Common Structural Rules for Bulk Carriers and Oil Tankers

Urgent Rule Change Notice 1 to 01 JAN 2014 version

URGENT RULE CHANGE NOTICE 1

This proposal contains amendments within the following Parts and chapters of the Common Structural Rules for Bulk Carriers and Oil Tankers, 1 January 2014. The amendments are effective on 1 July 2015.

Figure 4 : Basic design S-N curves, corrosive environment

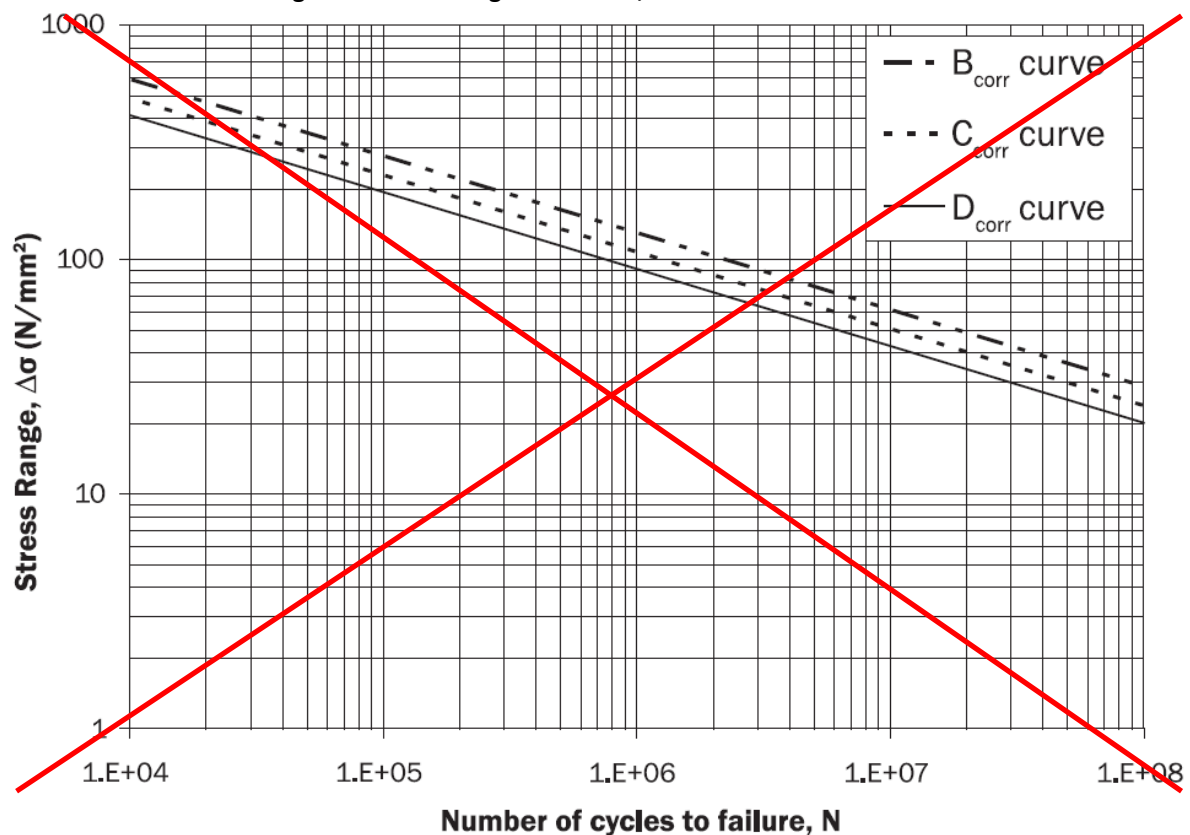
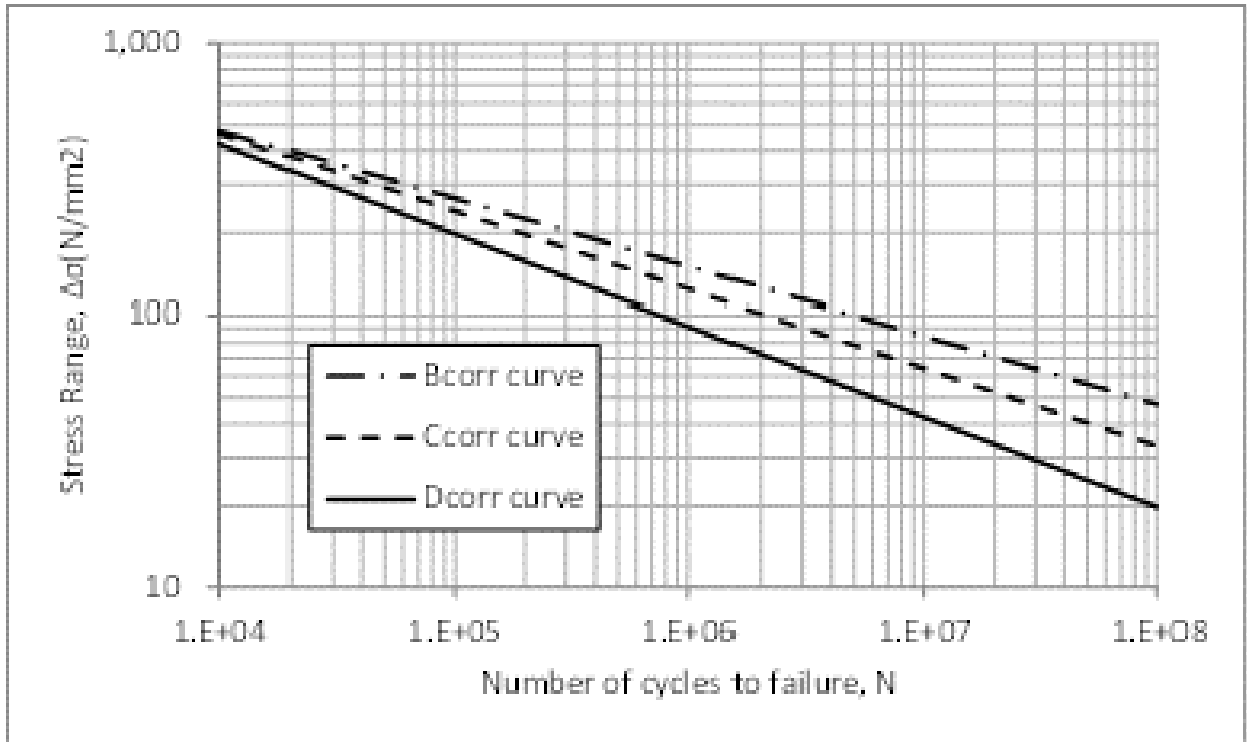
The basic design curves for corrosive environment shown in Figure 4 are represented by linear relationships between $\log(\Delta\sigma)$ and $\log(N)$ as follows:

Table 3 : Basic S-N curve data, corrosive environment

Class	K_2	m	Design stress range at 2×10^6 cycles, N/mm^2
B_{corr}	2.246E12	3.0	103.9
C_{corr}	1.267E12	3.0	85.9
D_{corr}	7.600E11	3.0	72.4

Class	K_2	m	Design stress range at 2×10^6 cycles, N/mm^2
B_{corr}	<u>5.05×10^{14}</u>	<u>4.0</u>	<u>126.1</u>
C_{corr}	<u>2.12×10^{13}</u>	<u>3.5</u>	<u>101.6</u>
D_{corr}	7.60×10^{11}	3.0	72.4
